**IEEE 802.1Qbf Editor's Report  
January 2010 Interim Meeting  
Austin, Texas USA**

# 802.1Qbf Draft 0.1 Task Group Ballot

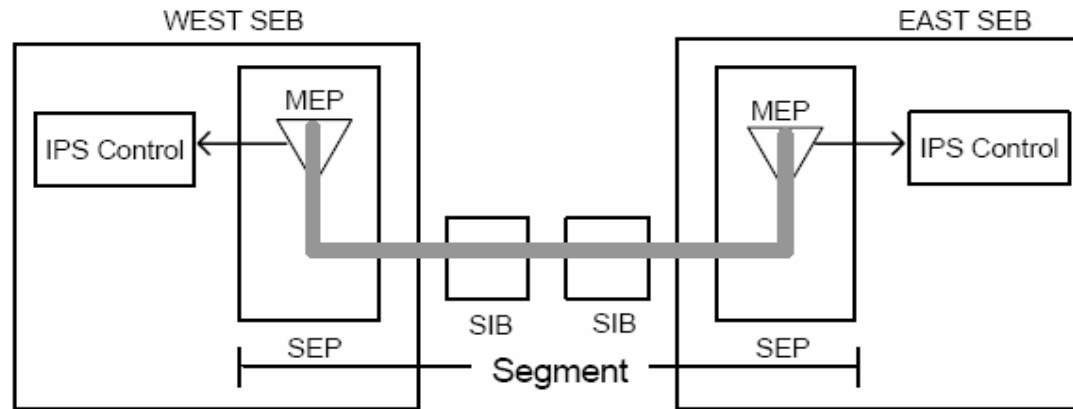
8. The comment suggests that the IPG maintain a list of TESIs rather than a list of ESPs (or 3-tuples). The editor points out that the SEB need only maintain a list of the ESPs that enter the IPG via that SEB. That is, it specifies just one ESP out of the pair of ESPs that specify the TESI. This point definitely requires discussion. (I did accept comment 47, pointing-out that the list of 3-tuples was omitted in 12.20.1.2.2 but I want to make sure that there is agreement that this is a list of 3-tuples rather than a list of TESIs). #34, 35
